Re: BusConnects Lucan to City Centre Core Bus Corridor Scheme
Lucan to Dublin City Centre

Here is the South Dublin County Council submission on the current Lucan to City Centre Core Bus Corridor SID Planning Application. Please acknowledge receipt of our submission by email.

Please note that on the attached GA drawing sheets there are notes (Yellow boxes) added and here is a summary of those notes in the Table below:

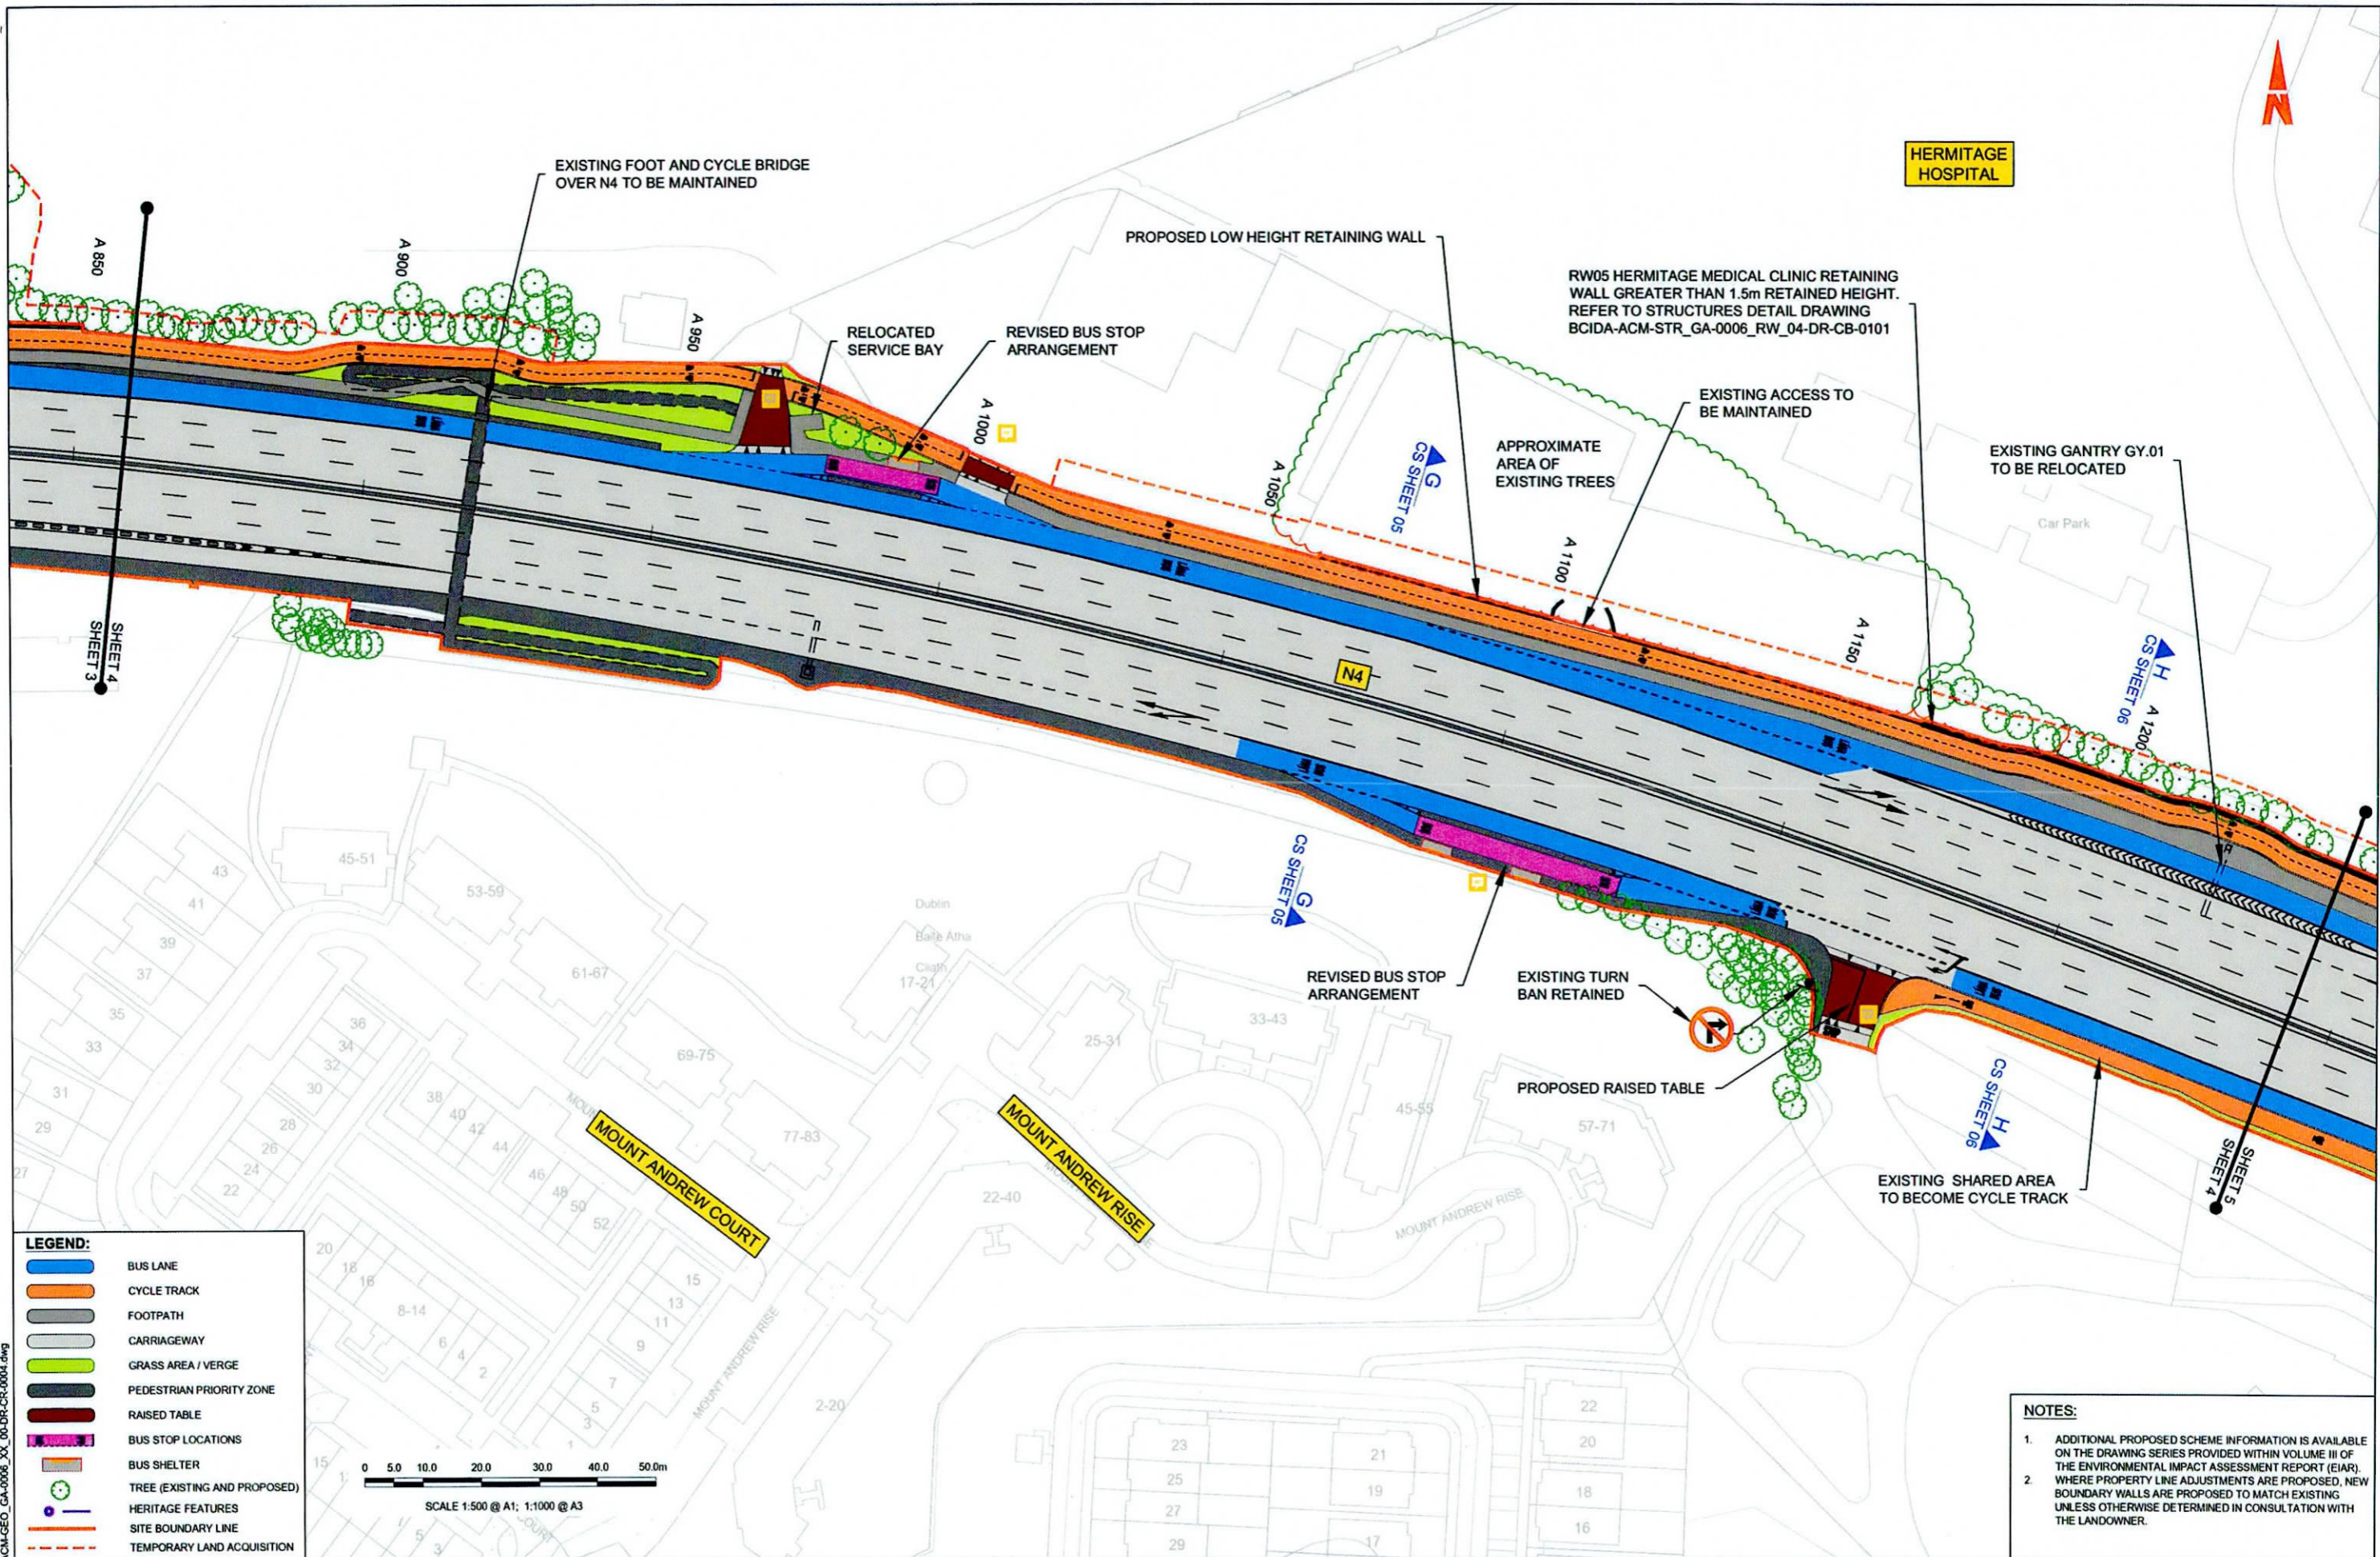
AT 20	Sheet 02		Hermitage Road	Junction tightening
AT 21	Sheet 03	CH A 650	N4	Assume it is anticipated that cyclist numbers will be >>> pedestrian numbers along this section and there benefit of footpath as a buffer for the cycle track outweigh concerns about peds between traffic lane and cycle track.
AT 22	Sheet 03	CH A 650	Bus stop on N4 westbound service road	Would an inline bus stop and bus stop bypass be a better solution at this location.
AT 23	Sheet 03	CH A 700	Junction of westbound N4 service road and Ballyowen Lane	How does a cyclist get from the shared path to the cycle track? As design stands, cyclist needs to: leave ped priority zone, cross an side road; join a cycle track (possibly by joining the side road and then joining the main road); leave a cycle track after c. 10 m; cross a bus stop and join a cycle track. Within approx 80 m.
AT 24	Sheet 03		Hermitage Park	What width is this shared path?

Programme Title	BUSCONNECTS DUBLIN CORE BUS CORRIDORS INFRASTRUCTURE WORKS				
Drawing Title	LUCAN TO CITY CENTRE CORE BUS CORRIDOR SCHEME GENERAL ARRANGEMENT				
Drawing File Name	BCIDA-ACM-GEO_GA-0006_XX_00-DR-CR-0004	Sheet Number	04 of 31	Status	A
Rev	M01

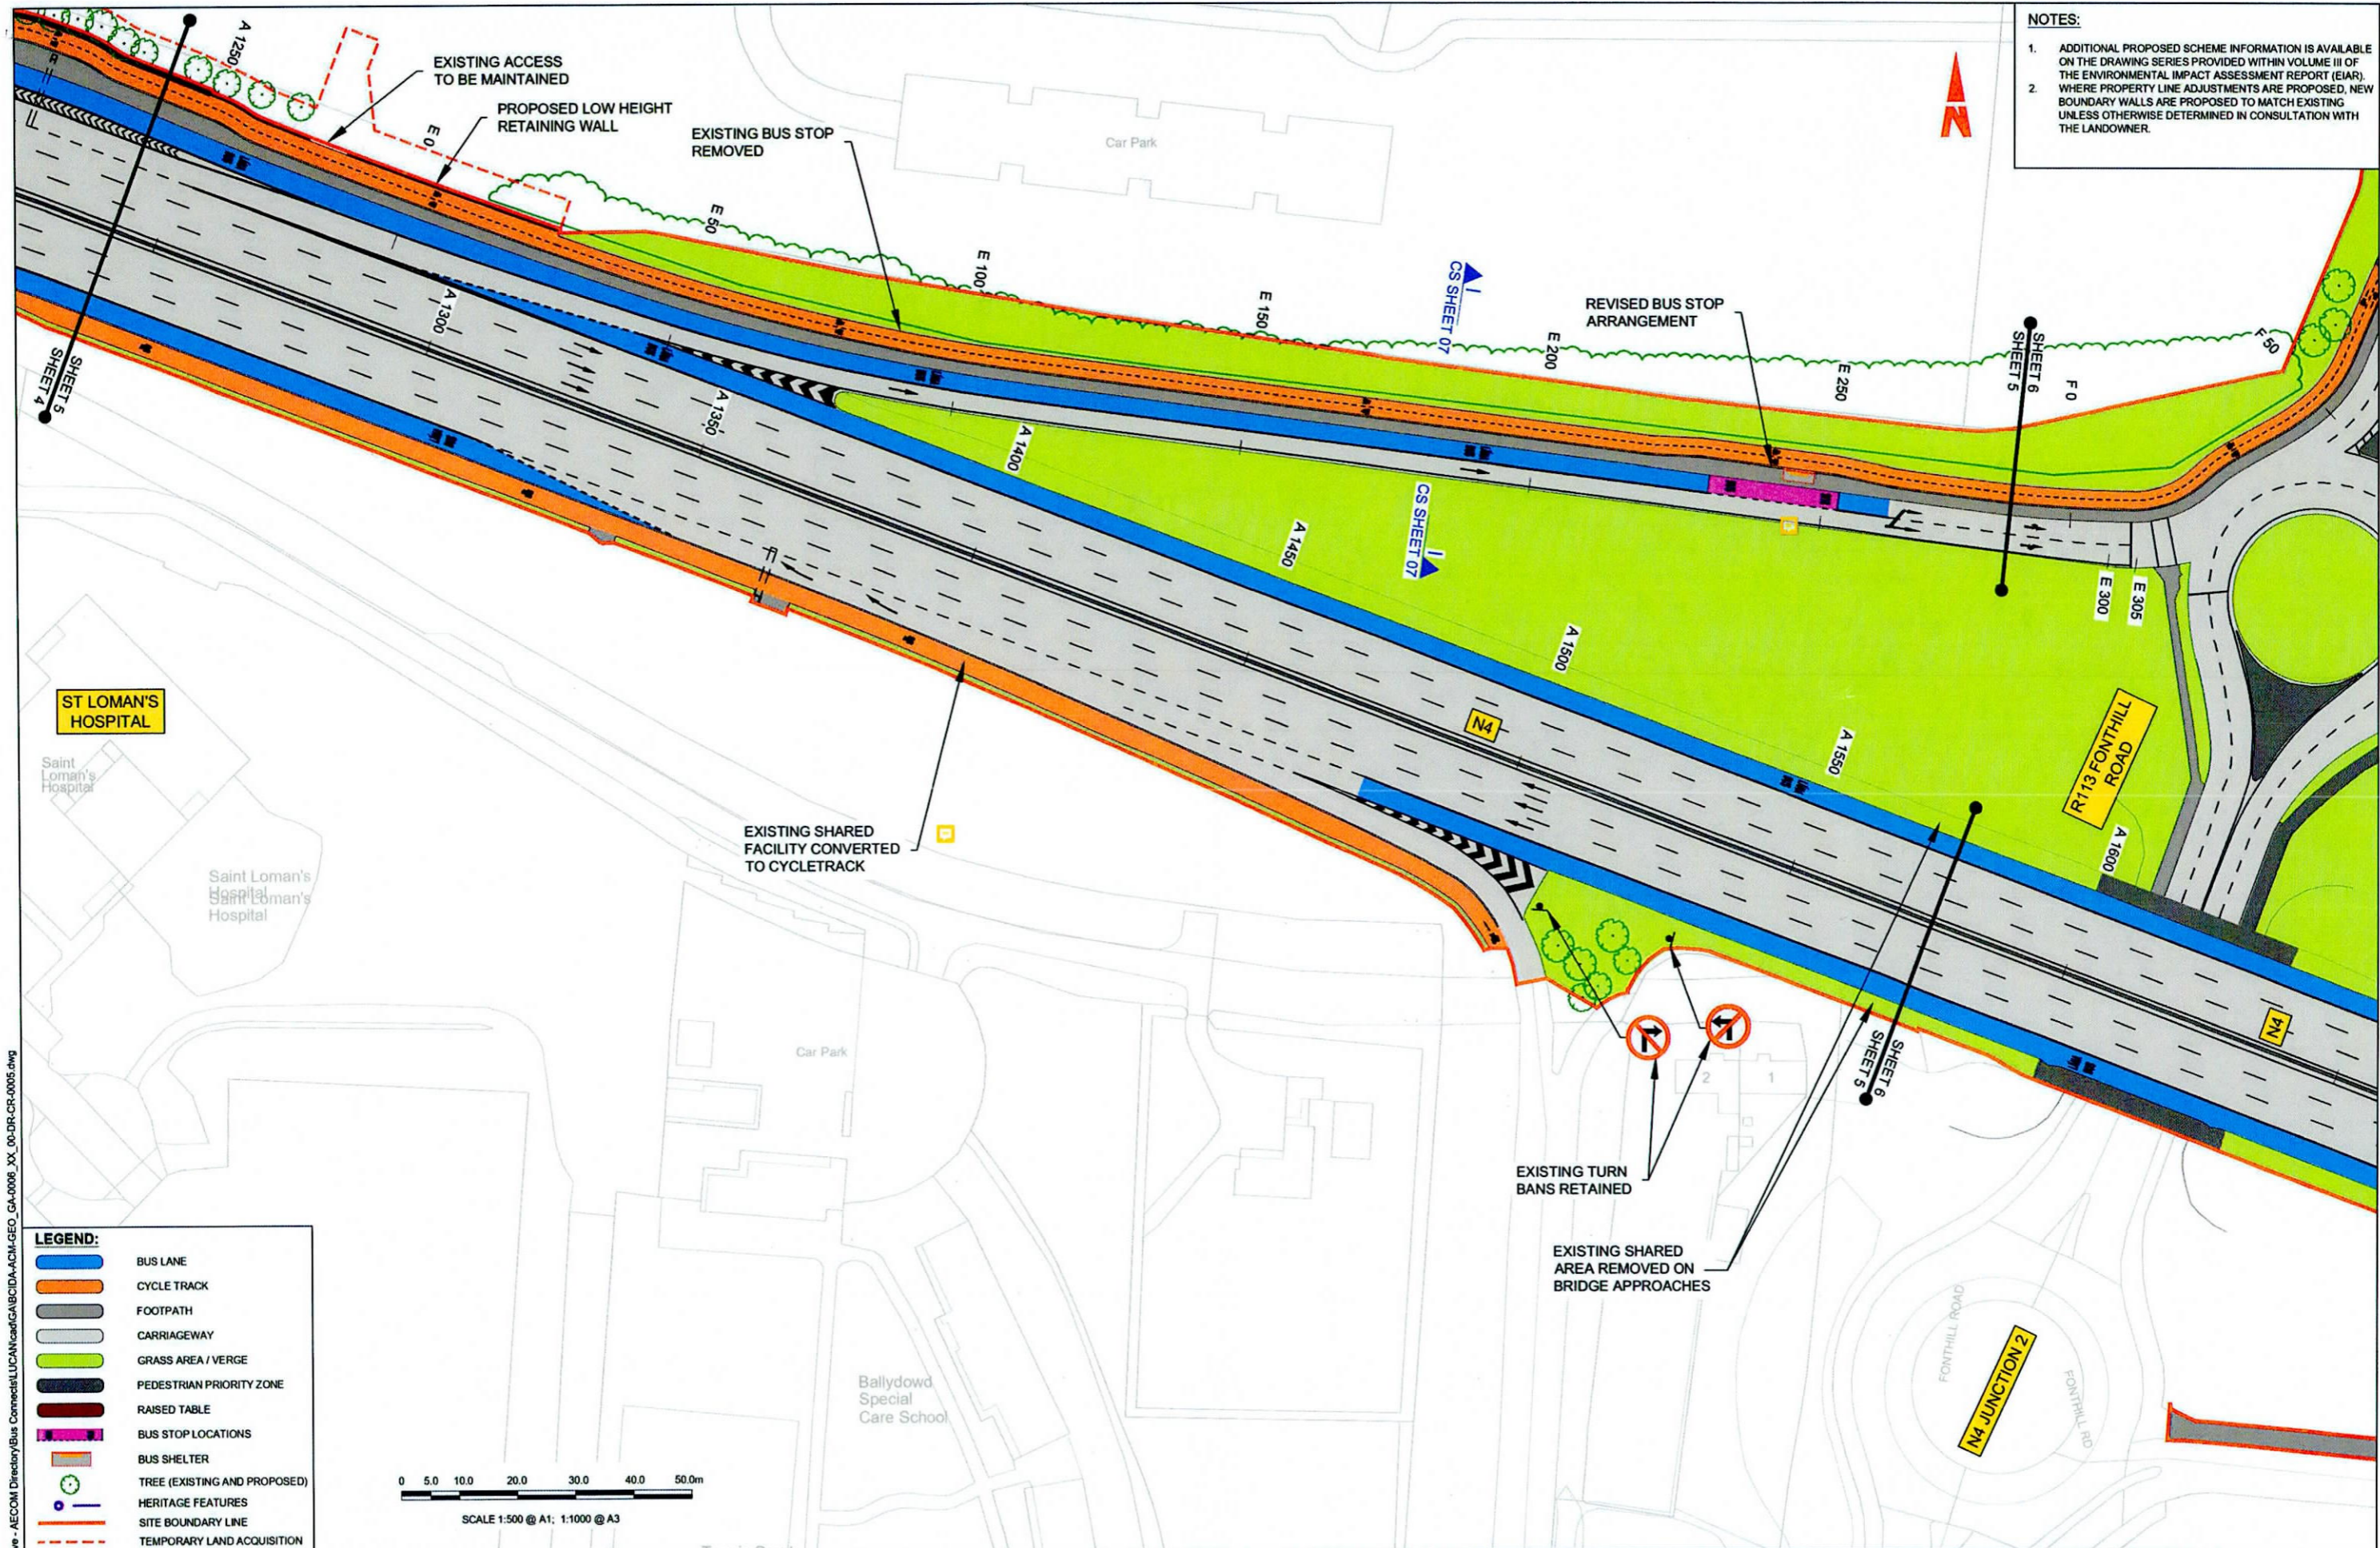
AT 25	Sheet 04	Ch A 1000	Entrance to east of pedestrian overbridge	Why are there stop lines on the cycle track at a private entrance?
AT 26	Sheet 04	Ch A 1000	Sureweld entrance	Is the table width < the cycle track width? Why are there stop lines on the cycle track at a private entrance?
AT 27	Sheet 04	Ch A 1110	Bus stop on westbound N4	What width is this shared use path which includes 2 no. bus shelters?
AT 28	Sheet 04	CH A 1150	N4 to Saint Loman's Hospital junction	Do turning vehicles have priority over straight ahead cyclists?
AT 29	Sheet 05	CH E 250	Eastbound N4 off ramp to Liffey Valley	Where is it anticipated people who use this bus stop will come from/to? Is the footpath between cycle track and bus lanes still preferred at this location?
AT 30	Sheet 05	CG A 1400	Existing shared path converted to cycletrack	How will this be done in practice?
